CONTRACT CHANGE ORDER NO. _____
SHEET ___ OF ___

MARK	DATE	DESCRIPTIONS	BY	CH'D	CCO#
2	04/08/11	SUSPENSION CABLE MISCELLANEOUS DETAILS	GB	MN	185
1	01/28/11	MISCELLANEOUS CABLE SYSTEM DETAILS	GB	MN	37S1

SAN FRANCISCO OAKLAND BAY BRIDGE
EAST SPAN SEISMIC SAFETY PROJECT
SELF-ANCHORED SUSPENSION BRIDGE
(SUPERSTRUCTURE & TOWER)
EAST CABLE ANCHORAGE "E" LINE LAYOUT NO. 2

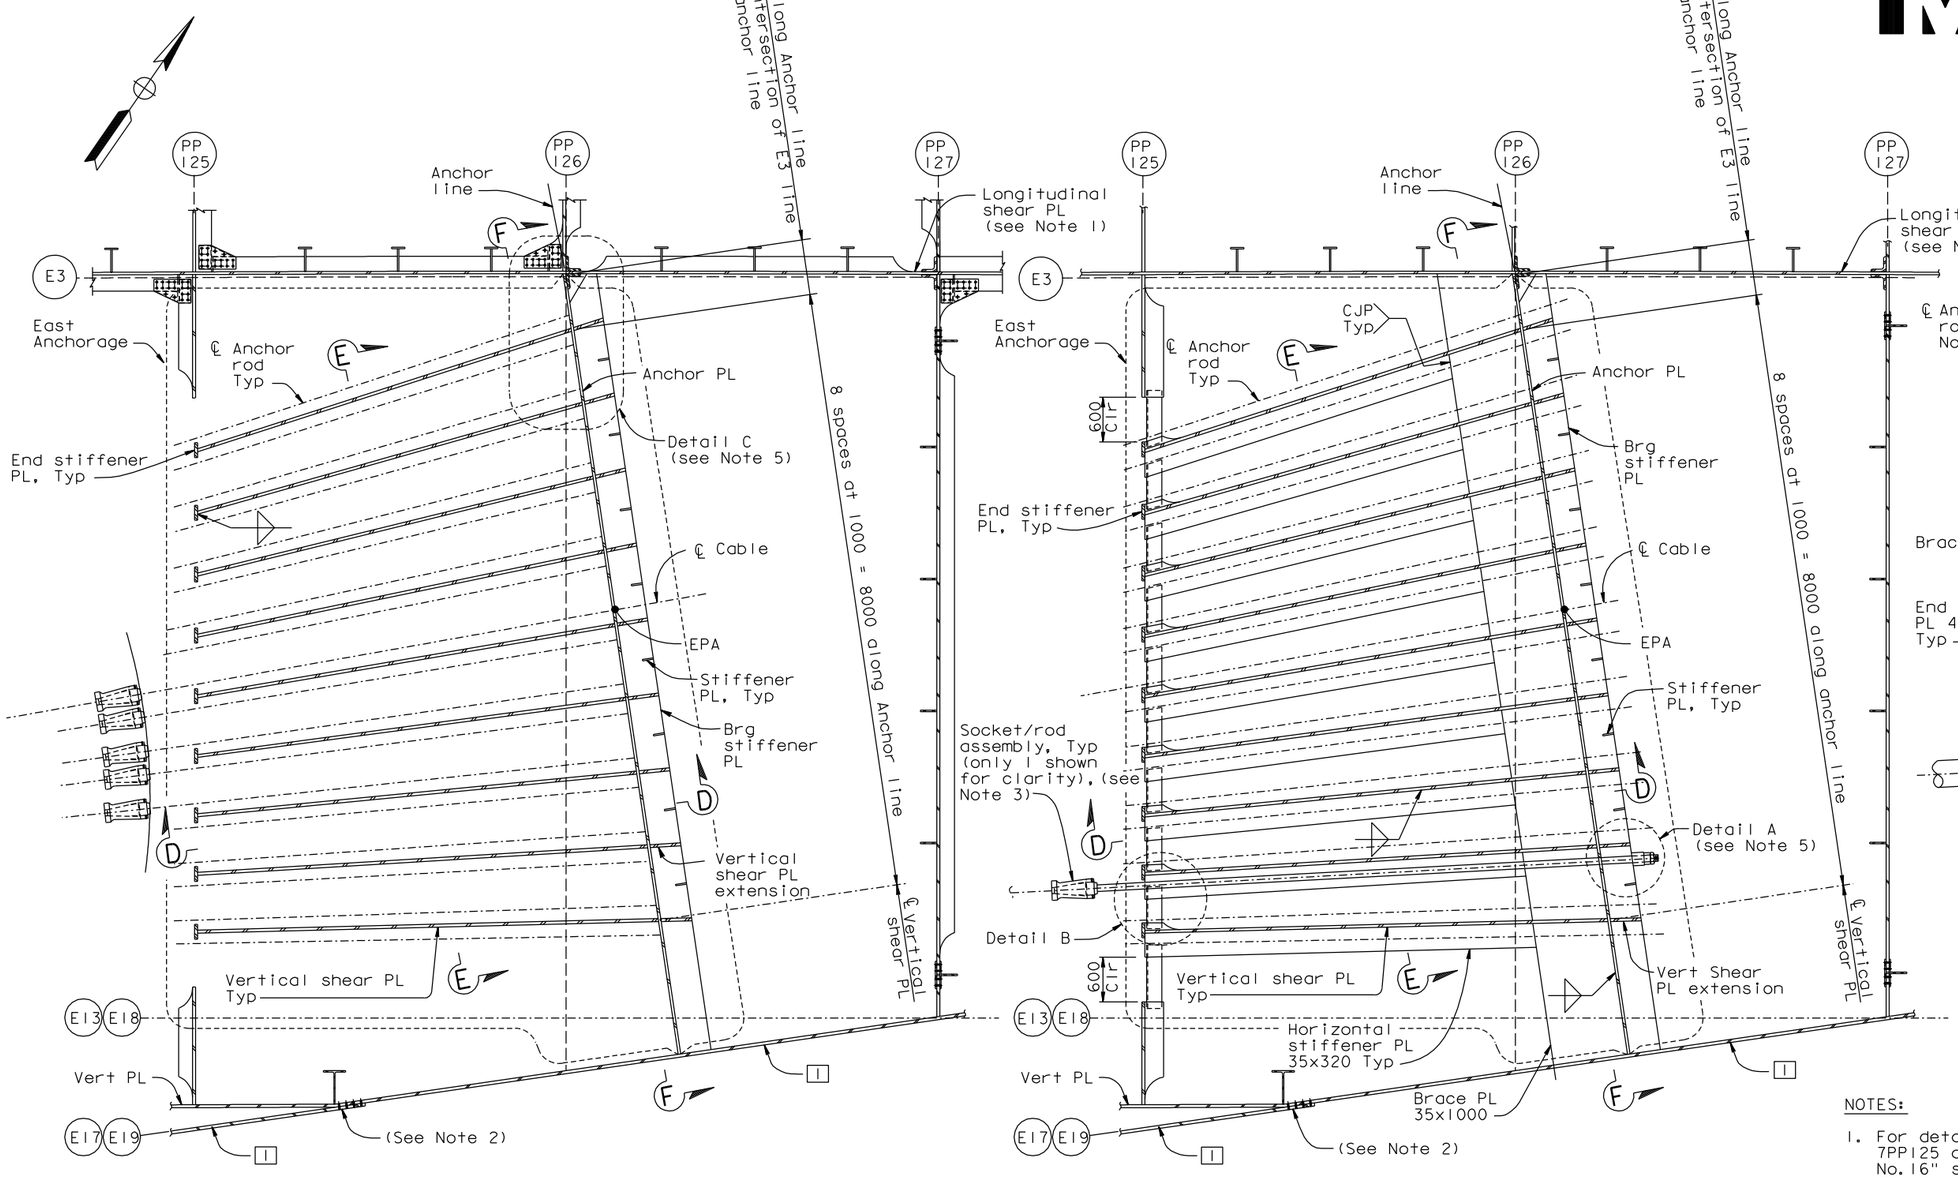
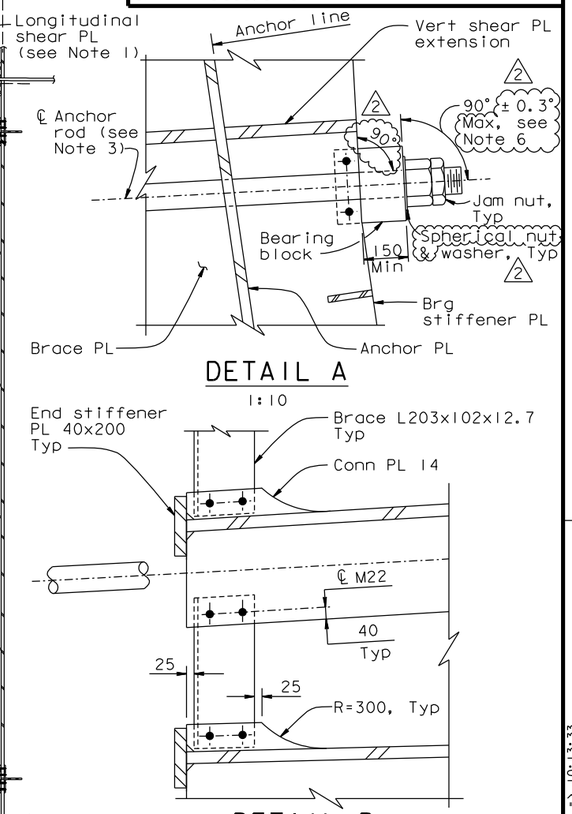
6. The bearing blocks shall be aligned with the bearing stiffener plates. The angle between the bearing block and the anchor rod may vary (up to 90° ± 0.3° Max) due to the averaging of the bearing stiffeners orientation across each row of anchors.

EAST CABLE ANCHORAGE "E" LINE LAYOUT NO. 3

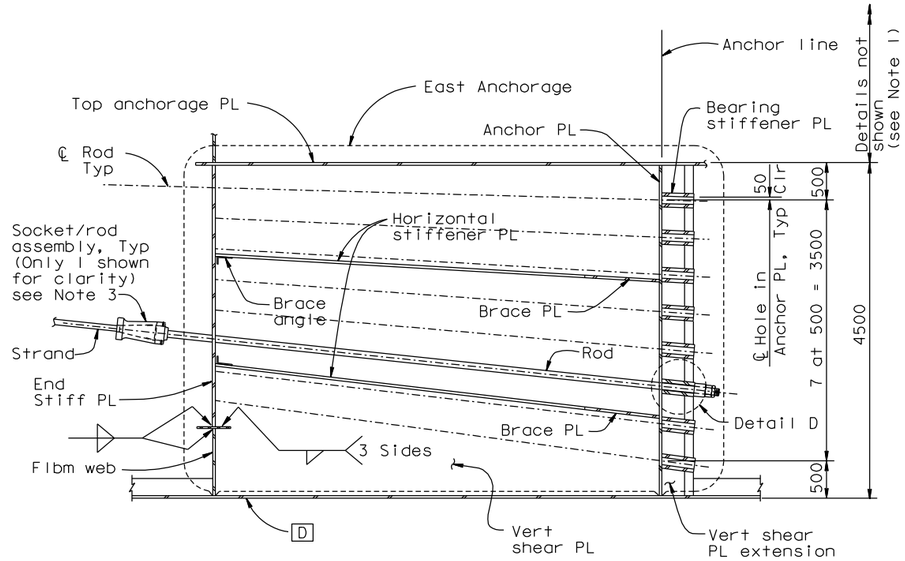
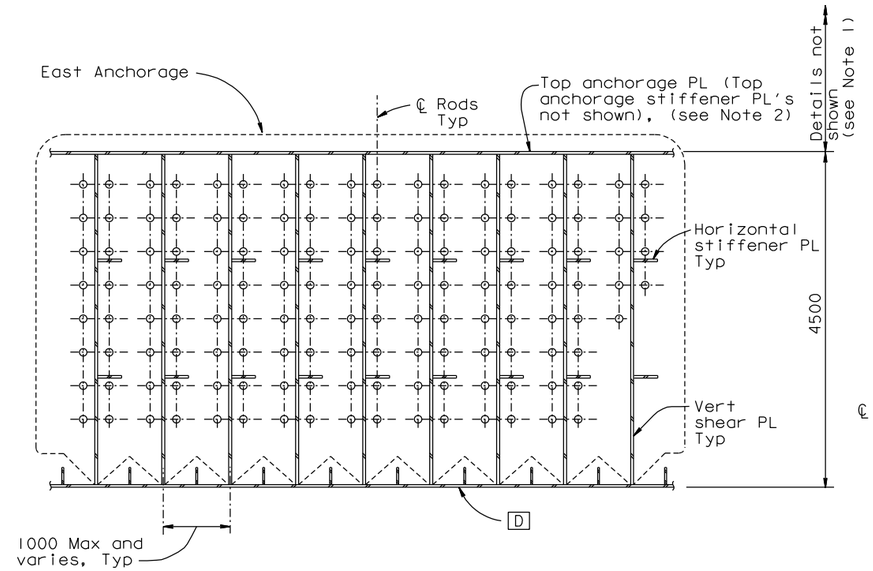
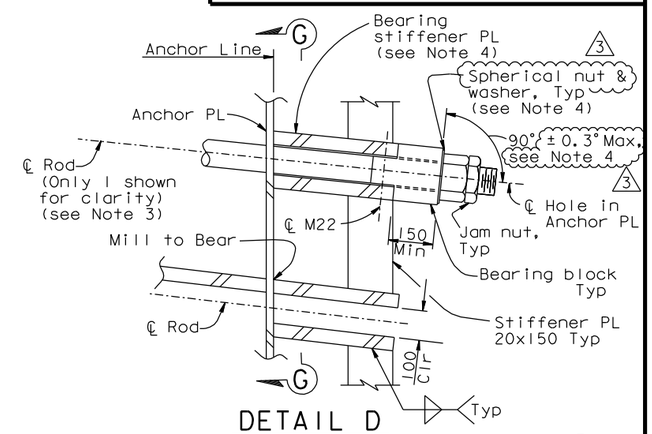
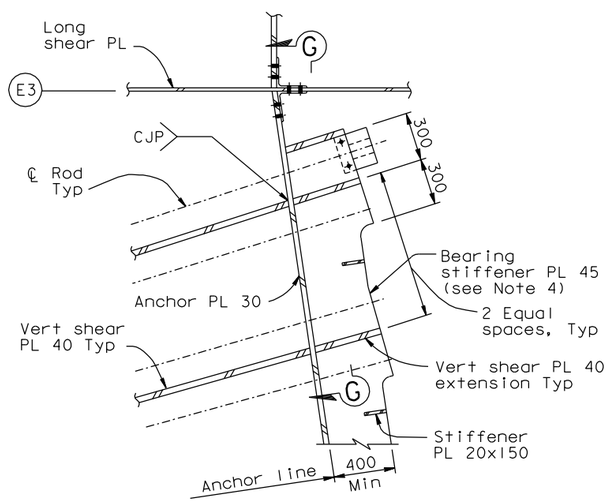
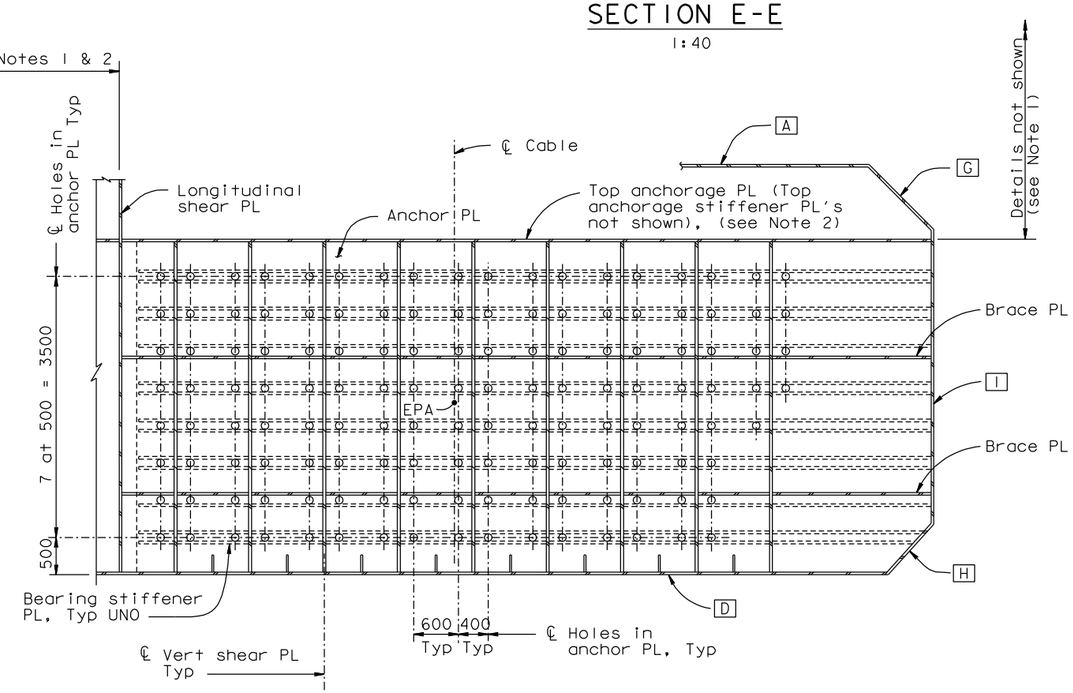
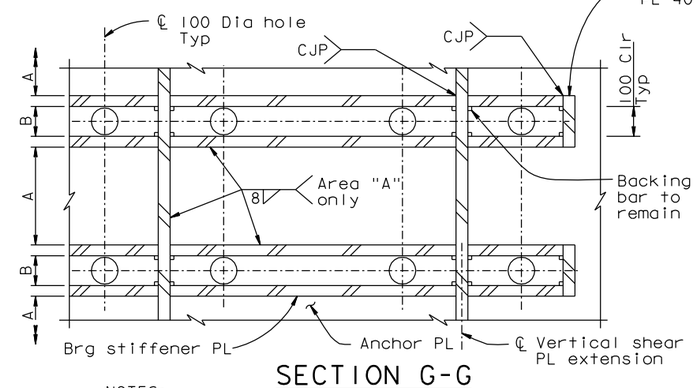
1. For girder details not shown, see "Girder At East Transition" sheets.
2. For top anchorage plate details not shown, see "Crossbeam at East Anchorage" and "Girder At East Transition" sheets.
3. For strand socket, transition anchor rod and bearing block details, see "East Cable Anchorage Details" sheet.
4. Bearing stiffener plates shall be machined to level the bearing block under the nut. Washers may be beveled to 1°. The installation tolerance for the bearing block/anchor rod angle is ±1°. Also see Note 6 on "East Cable Anchorage "E" Line Layout No. 2" sheet.

MARK	DATE	DESCRIPTIONS	BY	CH'D	CCO#
3	03/25/11	SUSPENSION CABLE MISCELLANEOUS DETAILS	DT	GB	185
2	01/28/11	MISCELLANEOUS CABLE SYSTEM DETAILS	DT	GB	37S1
1	08/28/09	BEARING BLOCKS	DT	GB	78

SAN FRANCISCO OAKLAND BAY BRIDGE
EAST SPAN SEISMIC SAFETY PROJECT
SELF-ANCHORED SUSPENSION BRIDGE
(SUPERSTRUCTURE & TOWER)
EAST CABLE ANCHORAGE "W" LINE LAYOUT NO.2

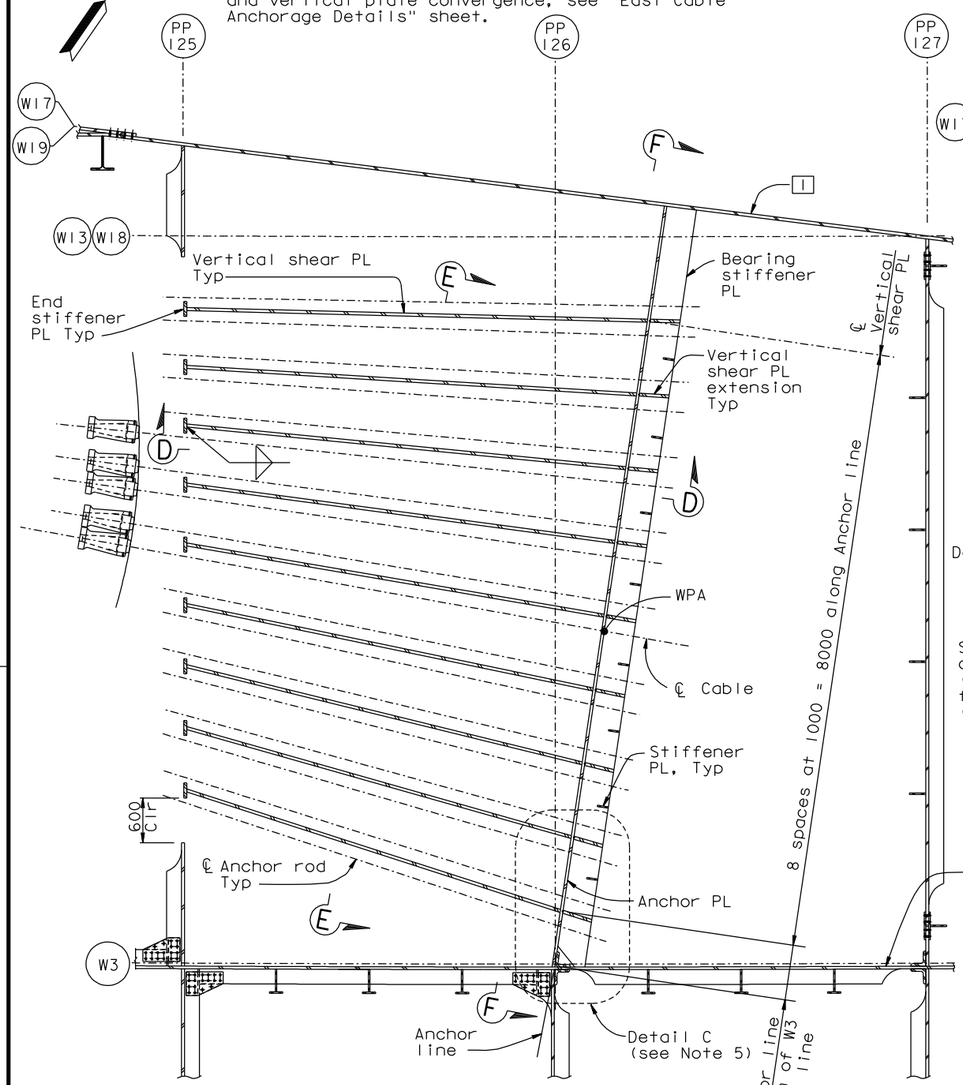
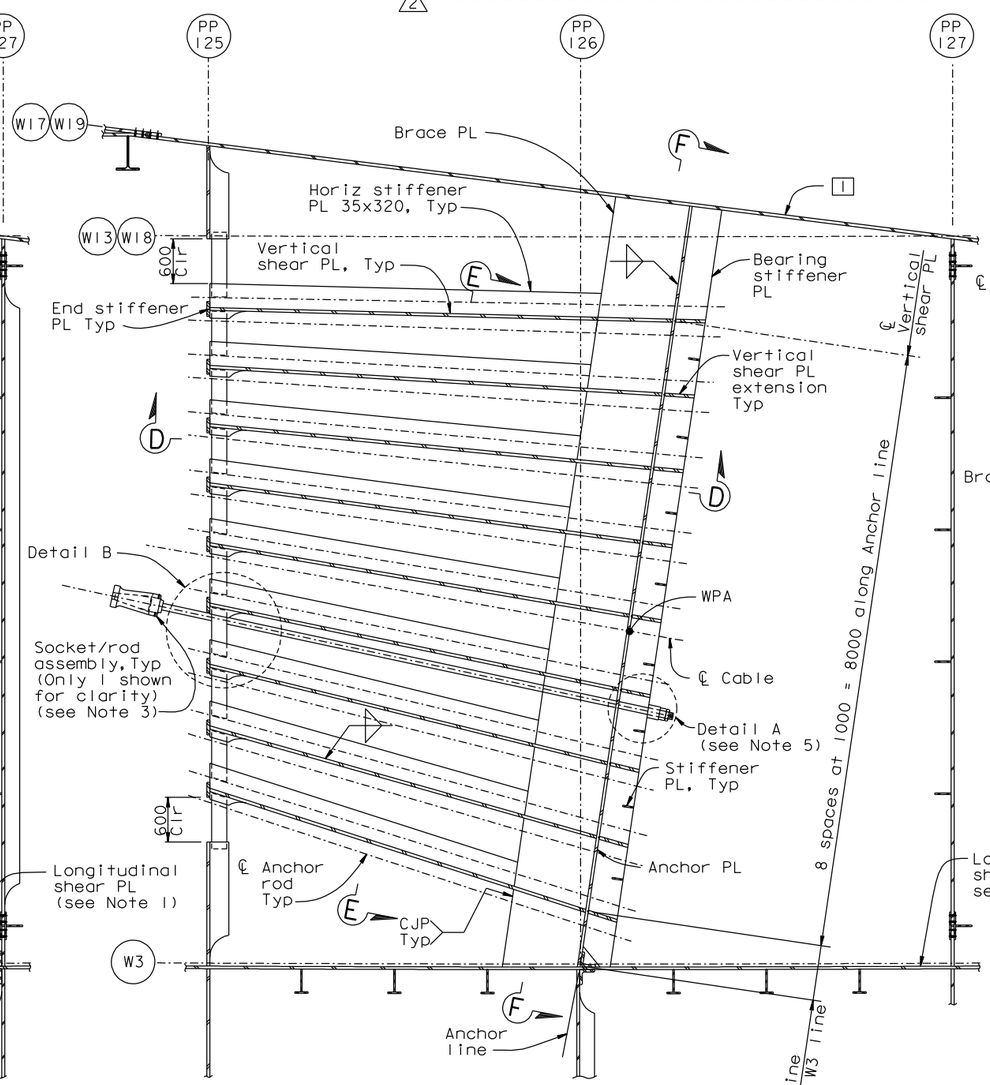
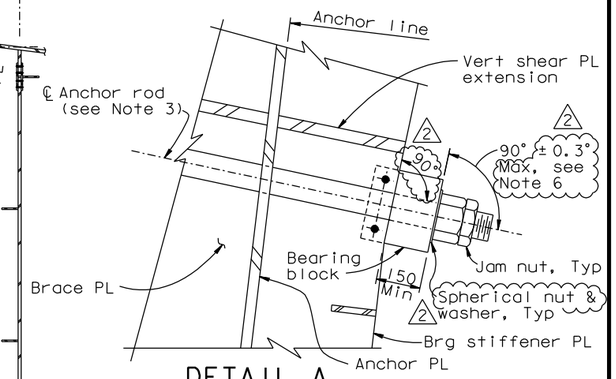
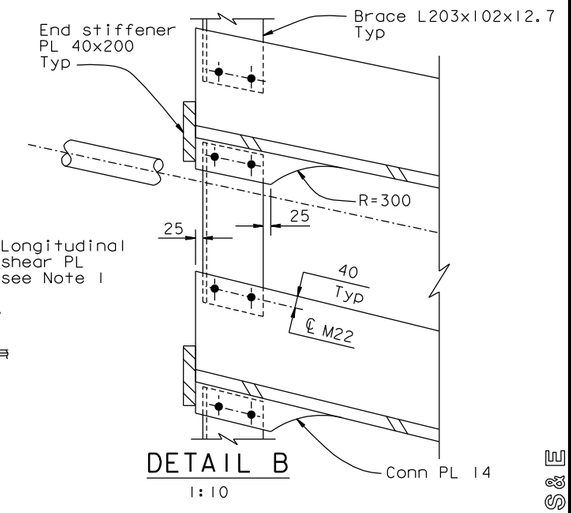
1. For details of longitudinal shear plate between PI25 and PP127, see "Girder At East Transition No.16" sheet.
2. For details of splice connection at girder plate and vertical plate convergence, see "East Cable Anchorage Details" sheet.
3. For strand socket and anchor rod details, see "East Cable Anchorage Details" sheet.
4. For Detail C and Sections D-D, E-E and F-F, see "East Cable Anchorage "W" Line Layout No.3" sheet.
5. Machining of bearing stiffener not shown in plan view.
6. The bearing blocks shall be aligned with the bearing stiffener plates. The angle between the bearing block and the anchor rod may vary (up to 90° ±0.3° Max) due to the averaging of the bearing stiffeners orientation across each row of anchors. (2)

MARK	DATE	DESCRIPTIONS	BY	CH'D	CCO#
2	04/08/11	SUSPENSION CABLE MISCELLANEOUS DETAILS	GB	MN	185
1	01/28/11	MISCELLANEOUS CABLE SYSTEM DETAILS	GB	MN	37S1

EAST CABLE ANCHORAGE "W" LINE LAYOUT NO. 3

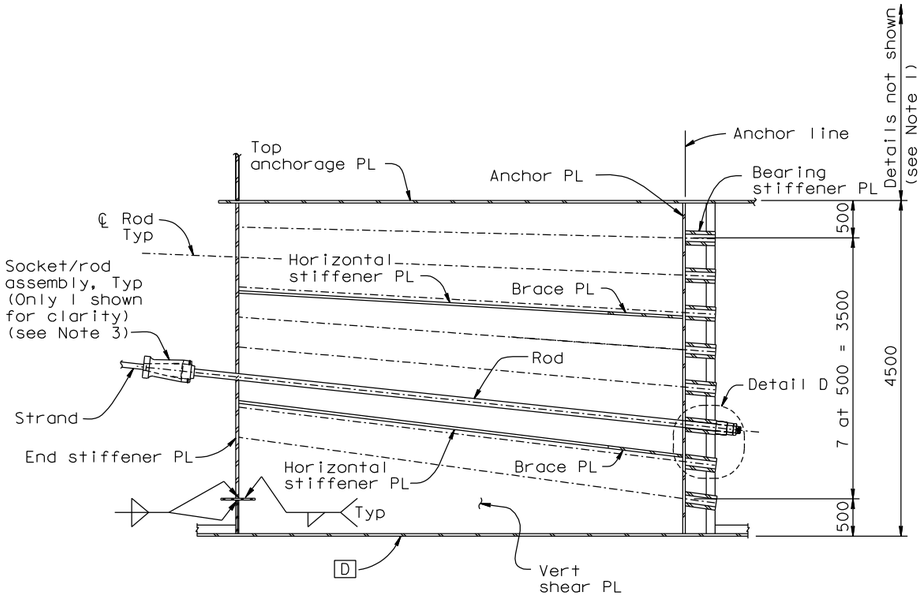
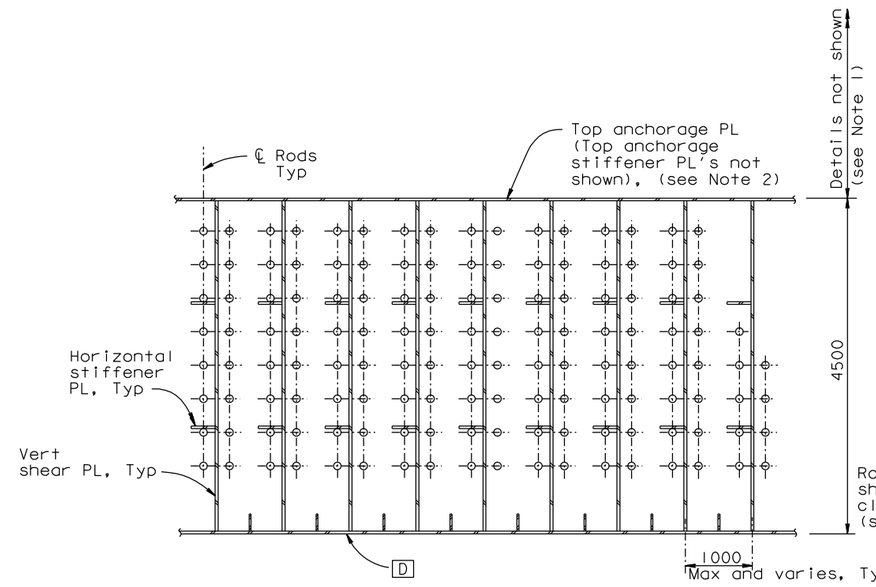
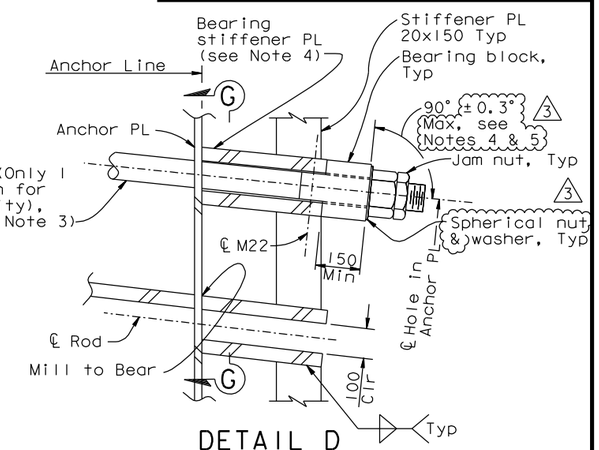
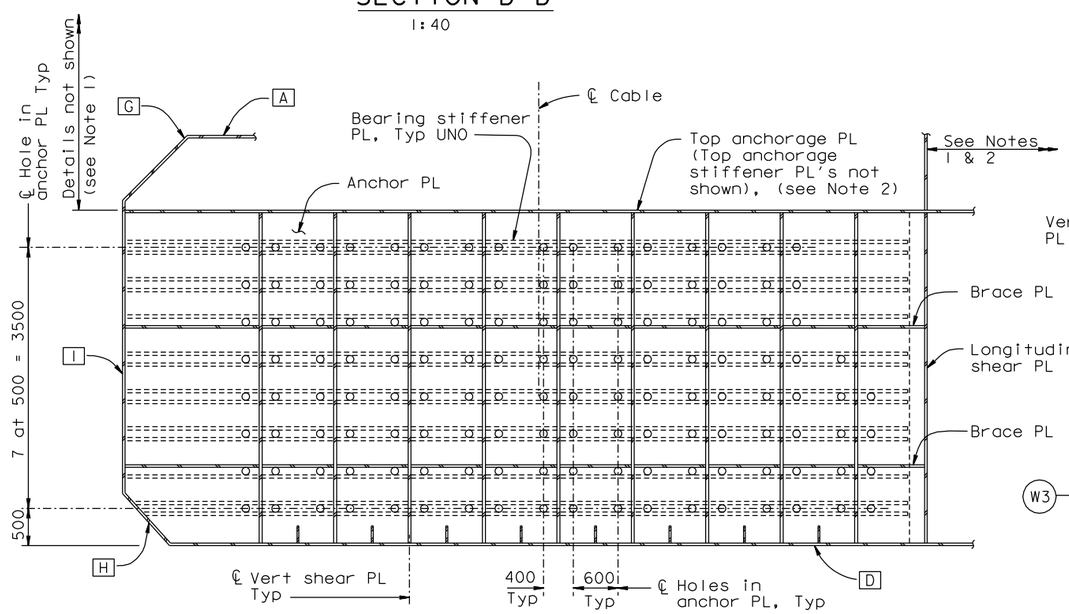
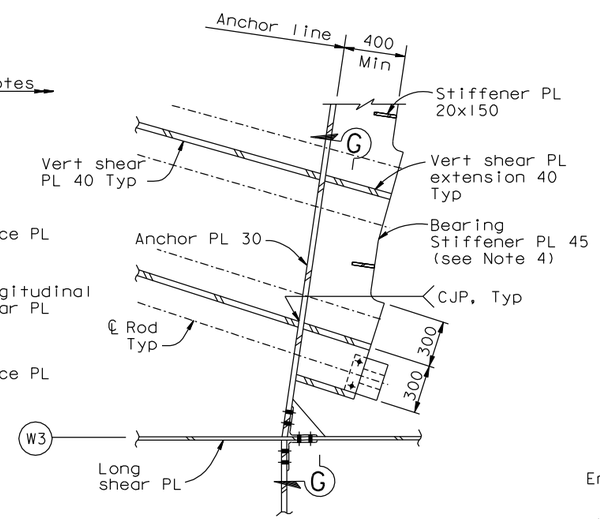
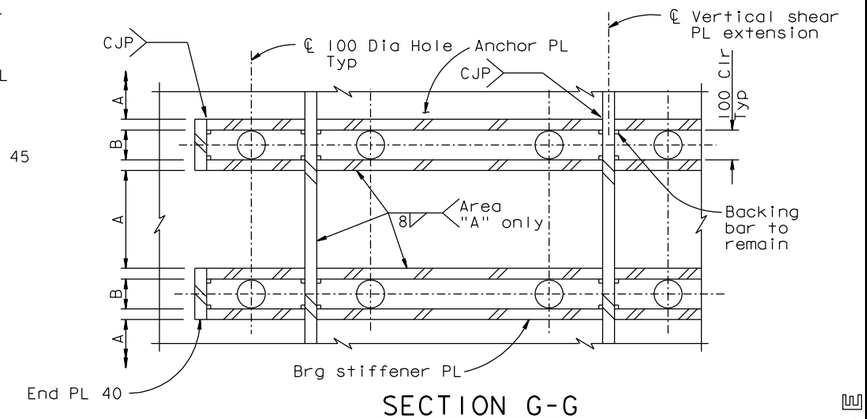
1. For girder details not shown, see "Girder At East Transition" sheets.
2. For top anchorage plate details not shown, see "Crossbeam At East Anchorage" and "Girder At East Transition" sheets.
3. For strand socket, transition anchor rod and bearing block details, see "East Cable Anchorage Details" sheet.
4. Bearing stiffeners plates shall be machined to level the bearing block under the nut. Washers may be beveled to 1°. The installation tolerance for the bearing block/anchor rod angle is ±1°. Also see Note 6 on "East Cable Anchorage "W" Line Layout No.2" sheet.
5. The bearing blocks shall be aligned with the bearing stiffener plates. The angle between the bearing block and the anchor rod may vary (up to 90° ±0.3° Max) due to the averaging of the bearing stiffeners across each row of anchors.

MARK	DATE	DESCRIPTIONS	BY	CH'D	CCO#
3	03/25/11	SUSPENSION CABLE MISCELLANEOUS DETAILS	DT	GB	185
2	01/28/11	MISCELLANEOUS CABLE SYSTEM DETAILS	DT	GB	37S1
1	08/28/09	BEARING BLOCKS	DT	GB	78
